West Winder Bypass
CSSTP-0006-00(327), P.I. No. 0006327
Barrow County

Value Engineering Study Report

April 2010

DESCRIPTION: **REALIGN THE BRIDGE OVER BANKHEAD HIGHWAY, THE
 CSX RAILROAD, AND SR 8 CLOSER TO A 90° SKEW**

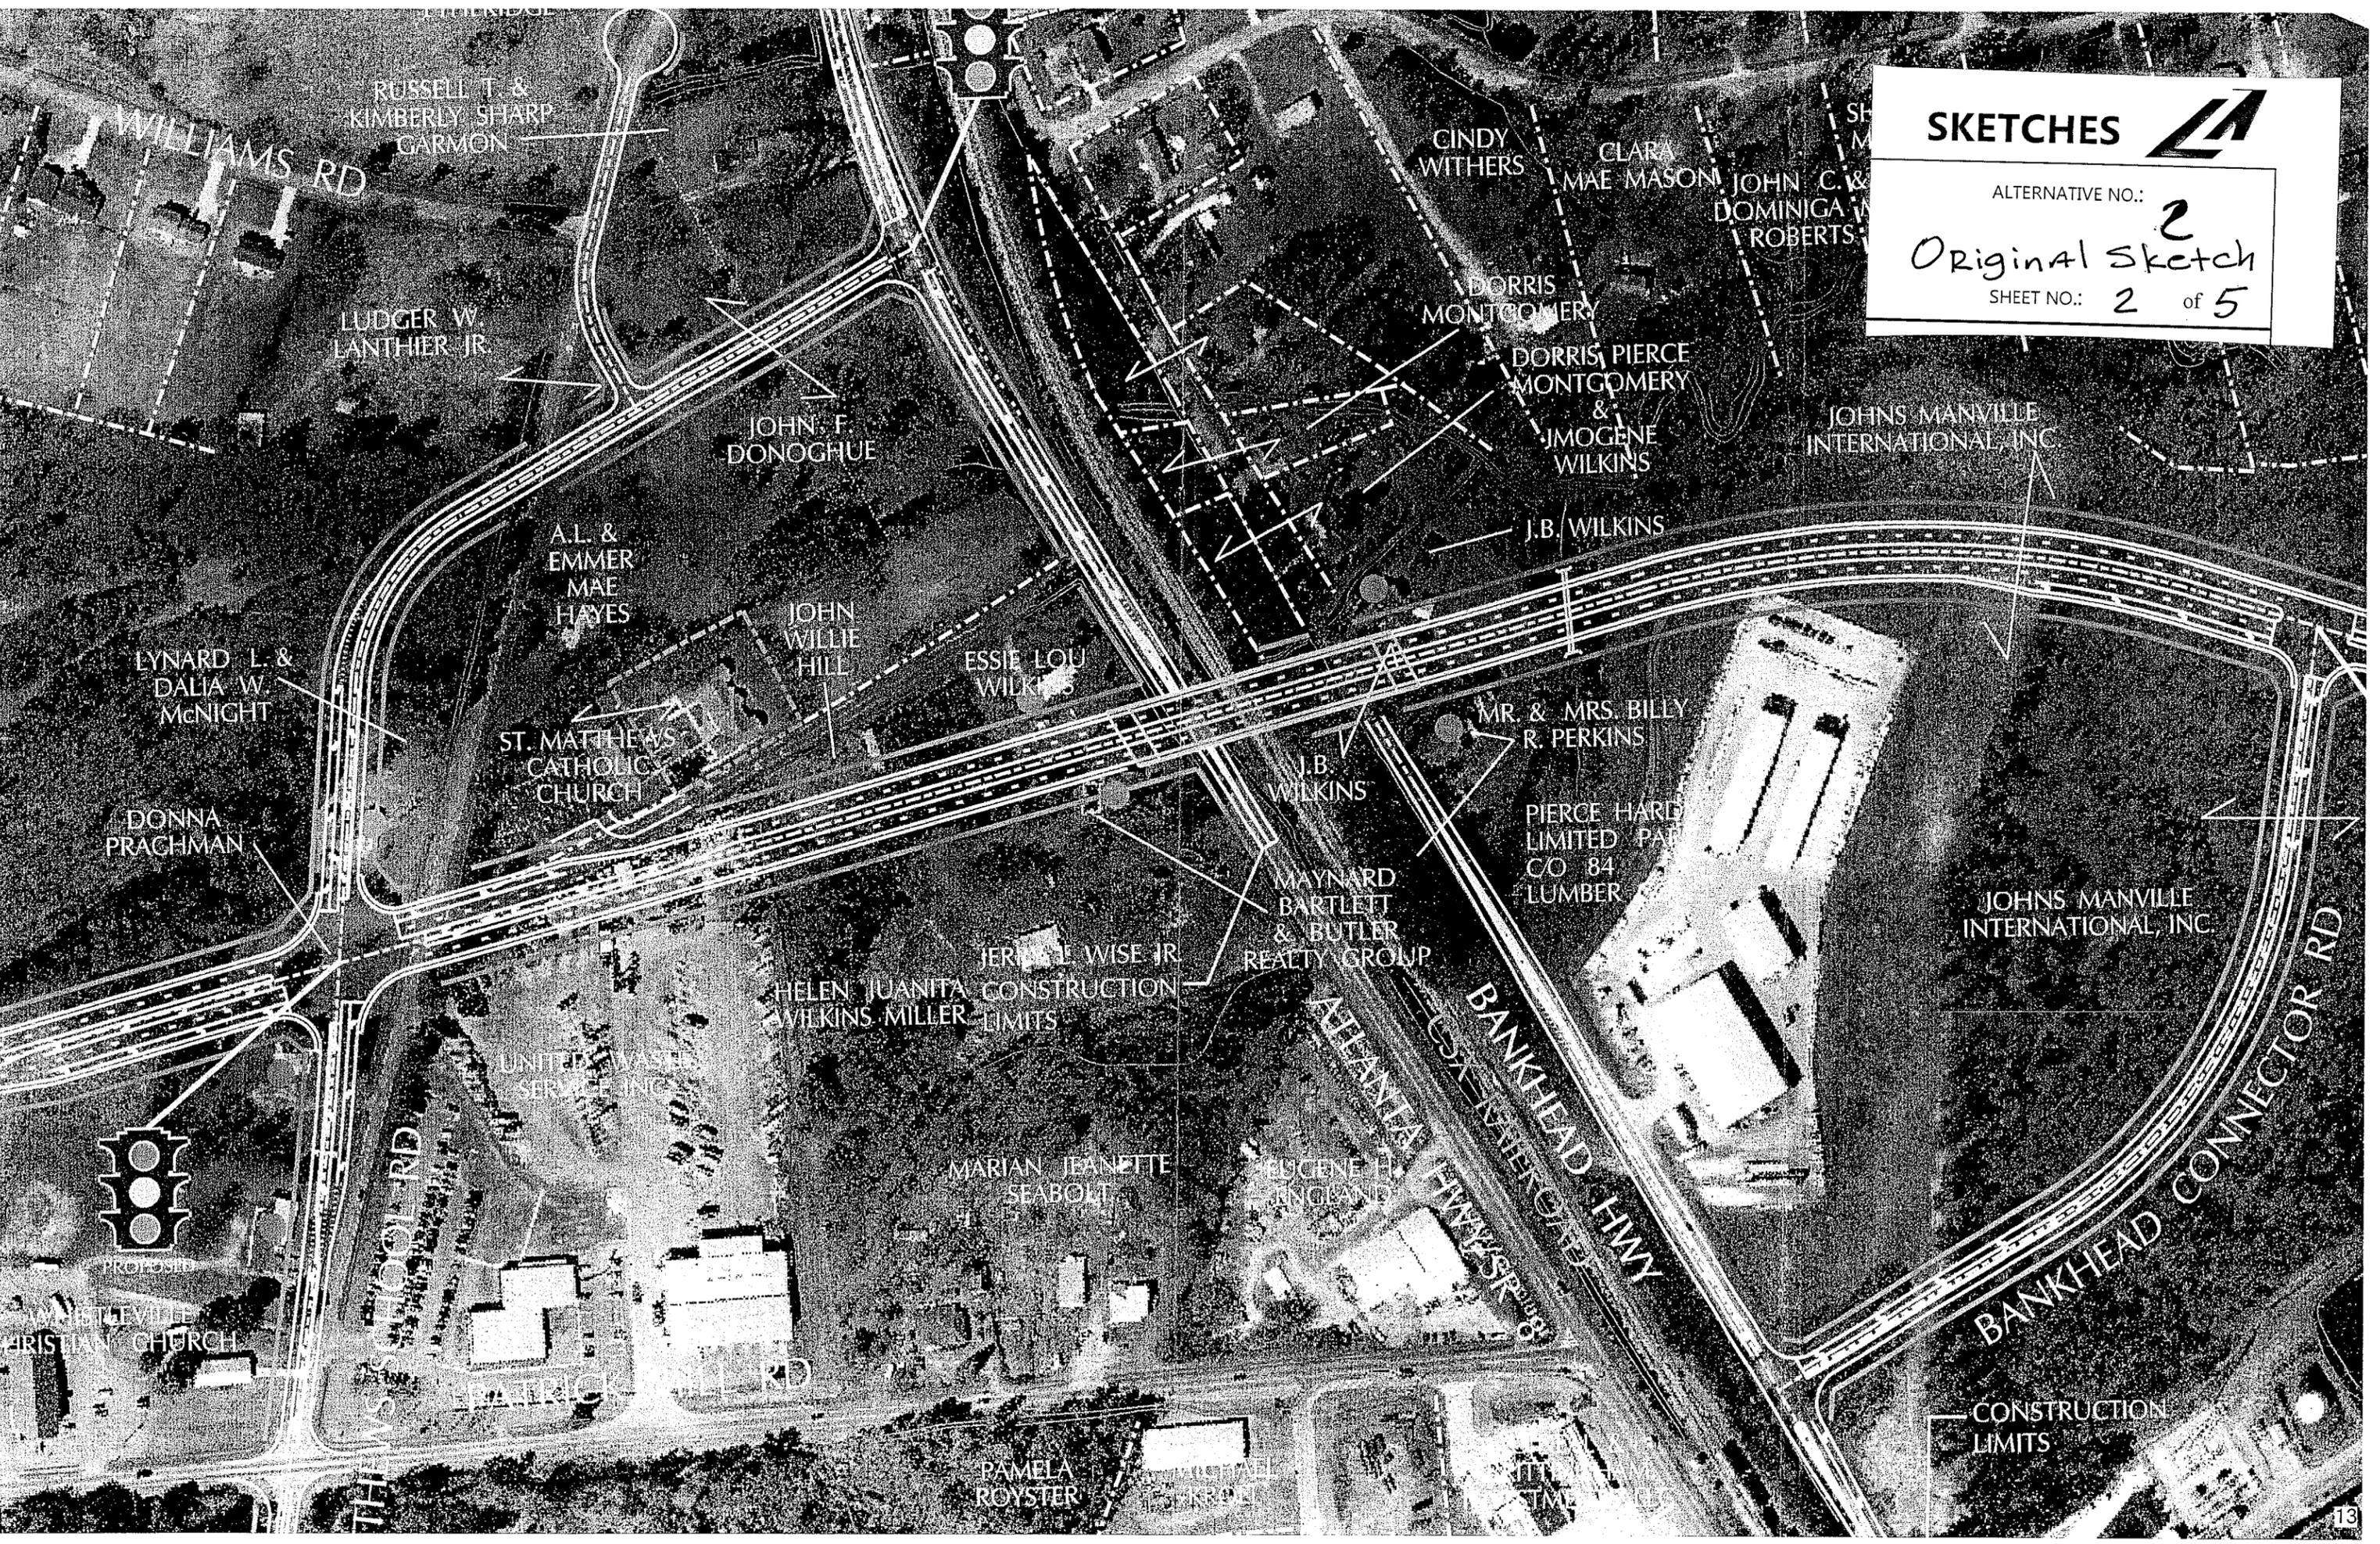
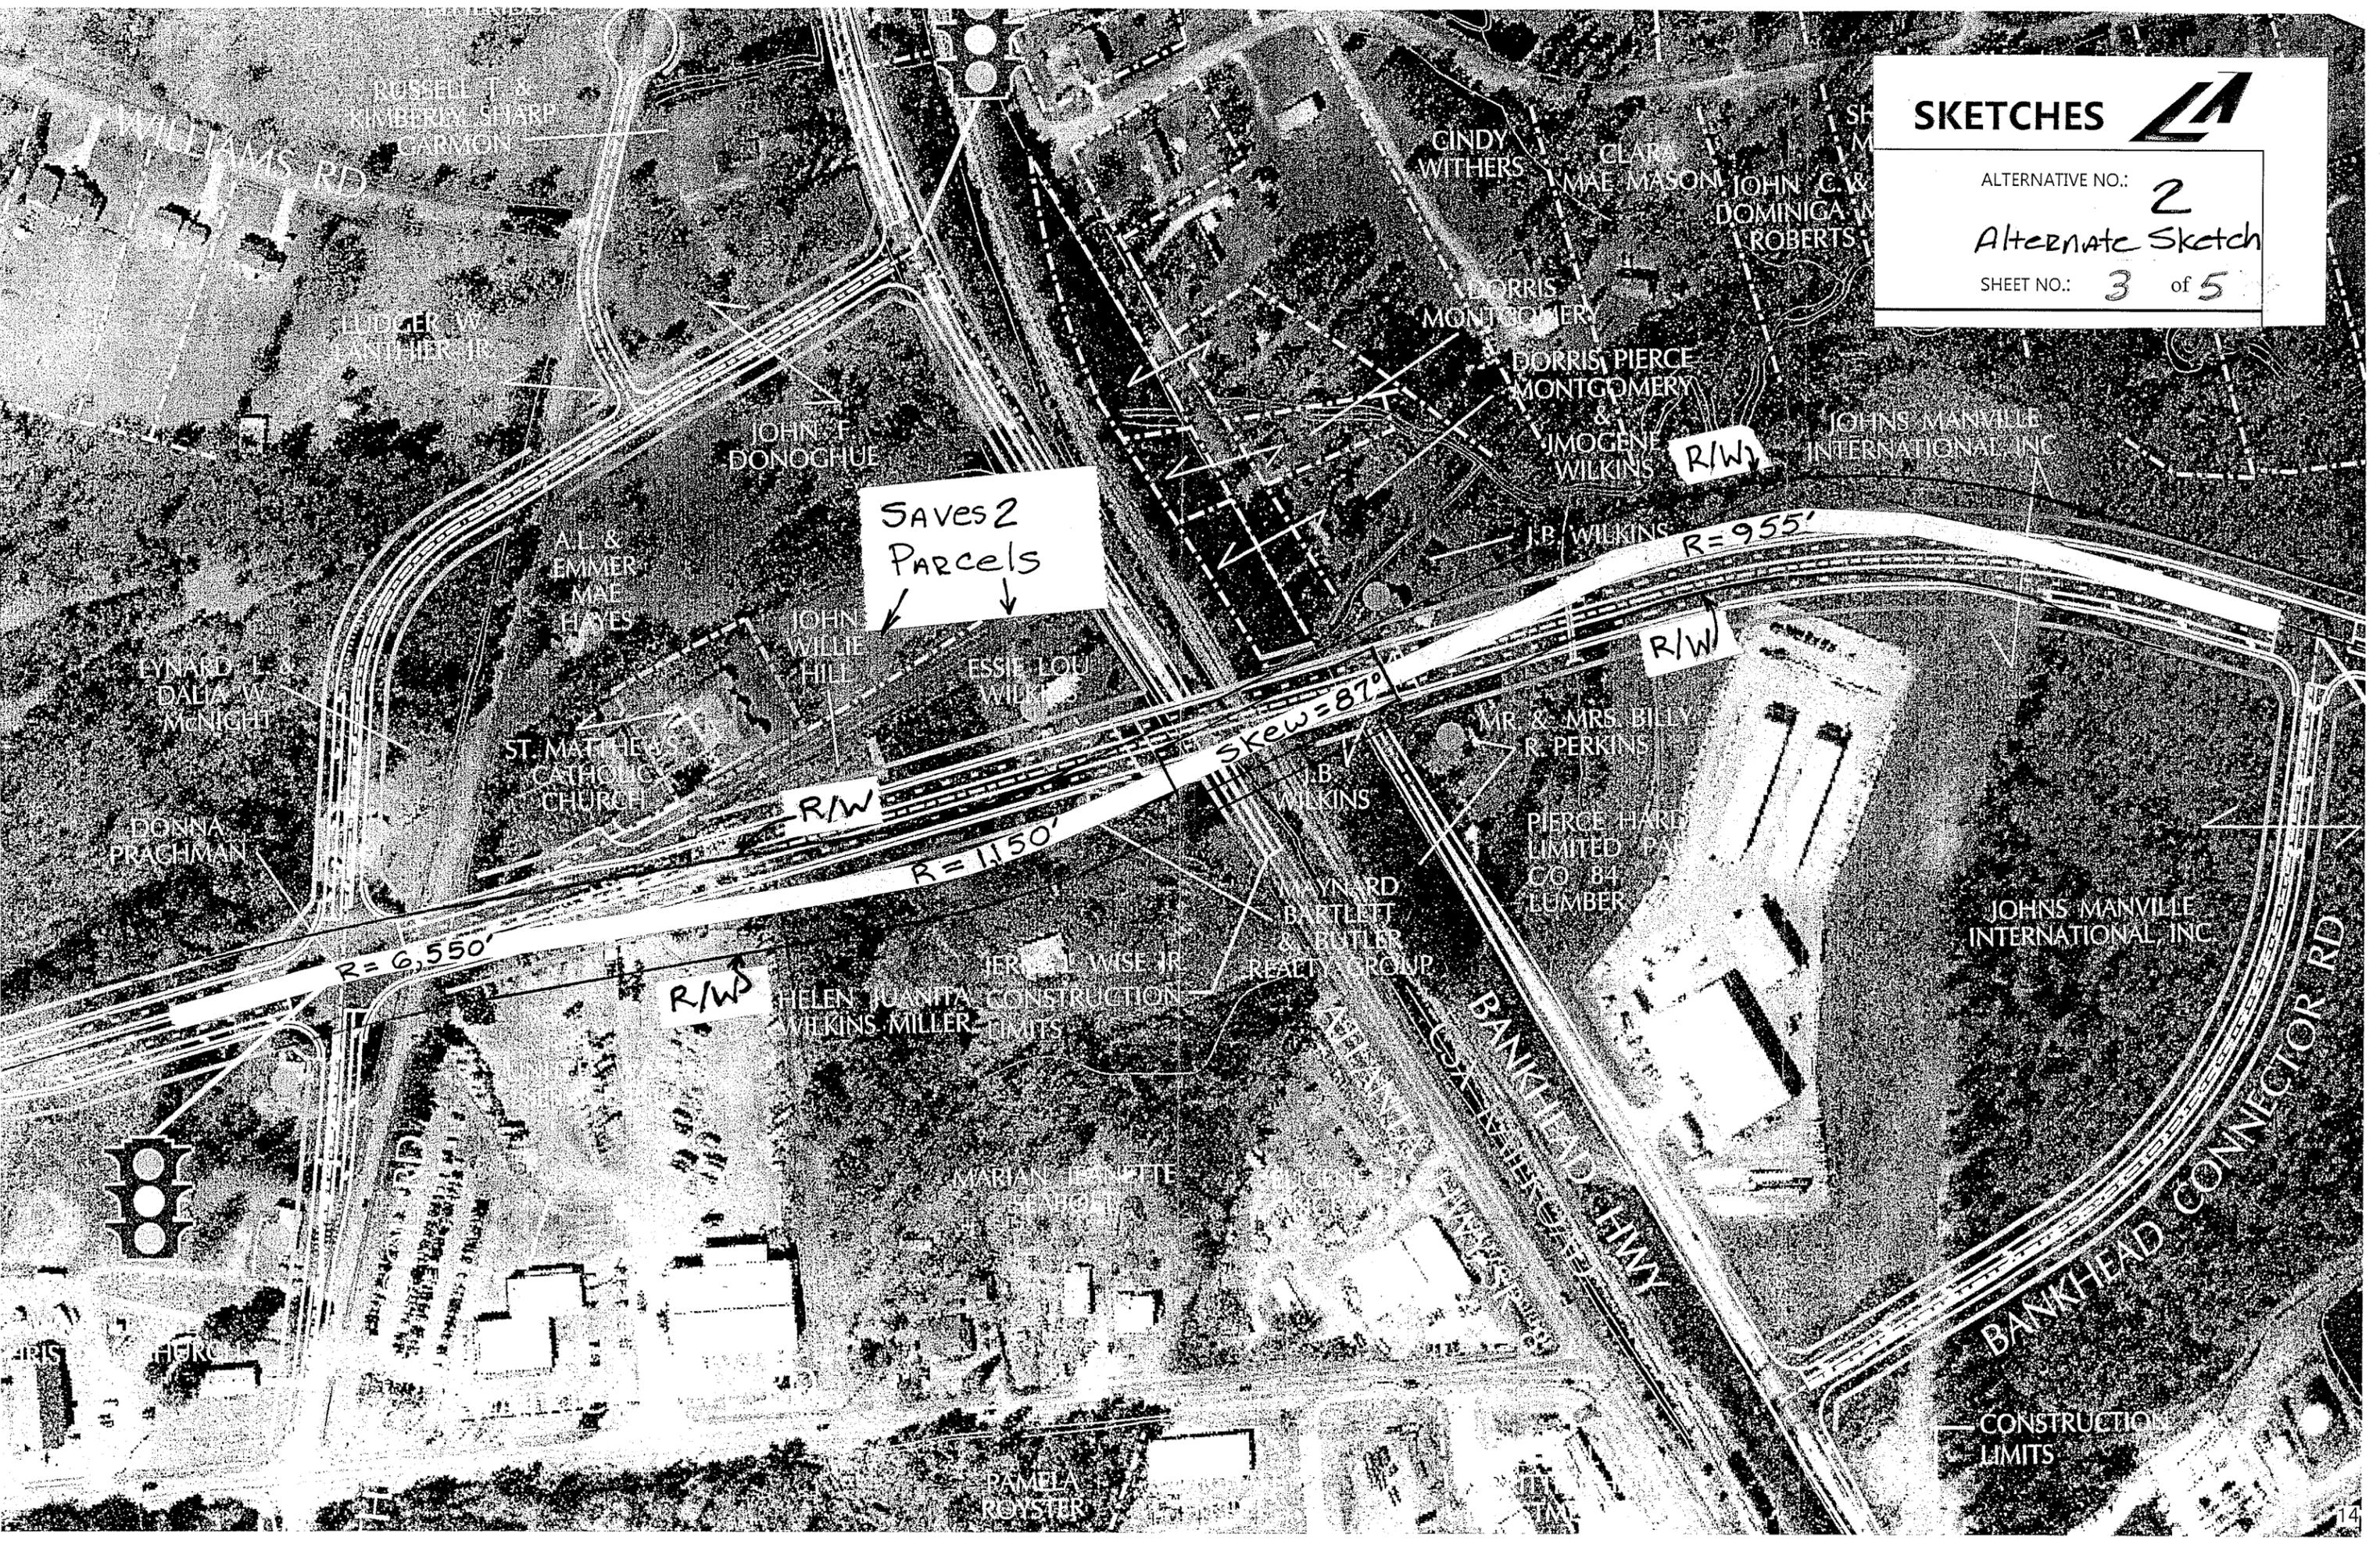
The original design skew angle for the West Winder Bypass bridge over Bankhead Highway, the CSX Railroad, and SR 8 is approximately 73°.

Realign the bridge to approximately a 90° skew.

The original design skew angle for the bridge over Bankhead Hwy, the CSX Railroad and SR 8 is 73°. The alternate alignment would save 20 ft. of bridge length by using a 90° skew angle. This realignment would also save a residential displacement and reduce the right-of-way impacts to the lumber yard property.

ALTERNATIVE NO.: 6

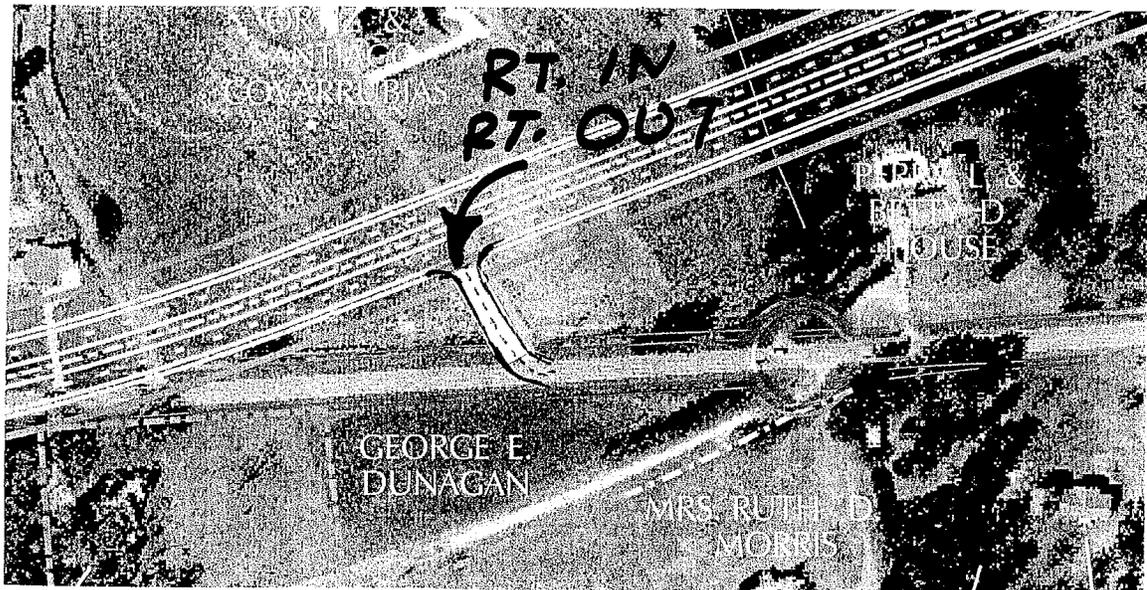
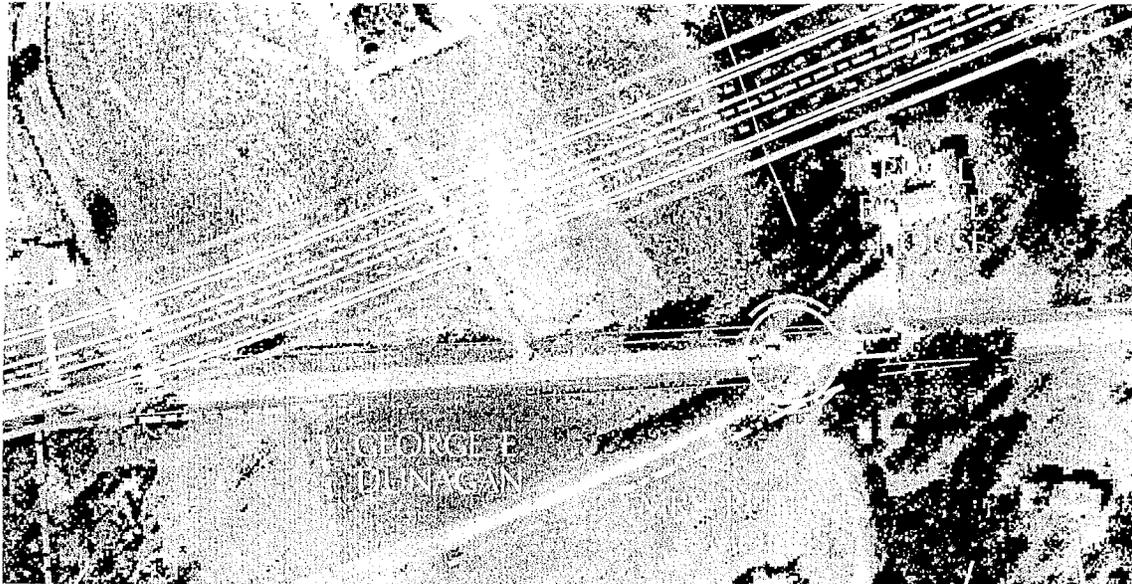
Provide a right-in, right-out intersection for existing Patrick Mill Road with the West Winder Bypass while retaining most of the existing pavement.

A right-in, right-out intersection will provide much easier access to the Bypass for local property owners needing to travel north. The cost savings from not demolishing the existing pavement and not constructing the cul-de-sac will be offset by the cost of constructing a right-in, right-out intersection. Additionally, the alternative design eliminates the need for property owners wanting to access the West Winder Bypass to travel 1,700 feet north to Matthews School Road and then another 700 feet west in order to access the Bypass to travel north as would be the case with the original design. They will still have to travel the same route if they want to travel south on the Bypass.

DESCRIPTION: **MOVE THE CUL-DE-SAC ON PATRICK MILL ROAD 500 FT. SOUTH TO PROVIDE ACCESS TO THE HISTORIC PROPERTY**

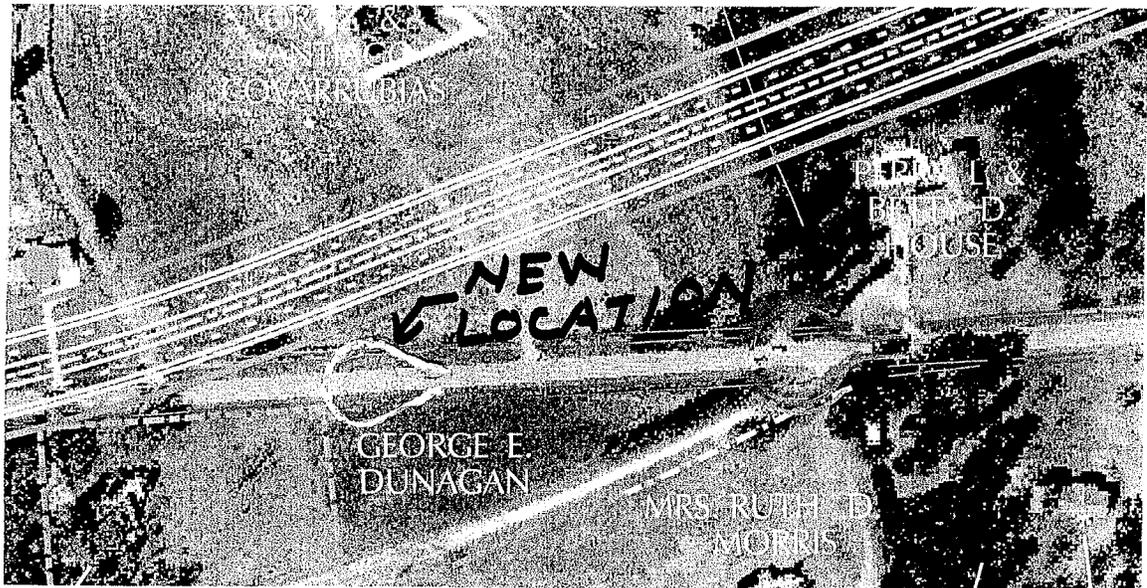
Construct a cul-de-sac on Patrick Mill Road 500 feet south of the original design location and remove the remaining 300 feet of pavement south of the cul-de-sac.

Since the existing Patrick Mill Road will be terminated by the construction of the new cul-de-sac, shifting the location of the cul-de-sac about 500 ft. south from the original design location would provide more and easier access to the current property owners while retaining as much of the existing pavement as possible. The cost implications of this exercise will be negligible.
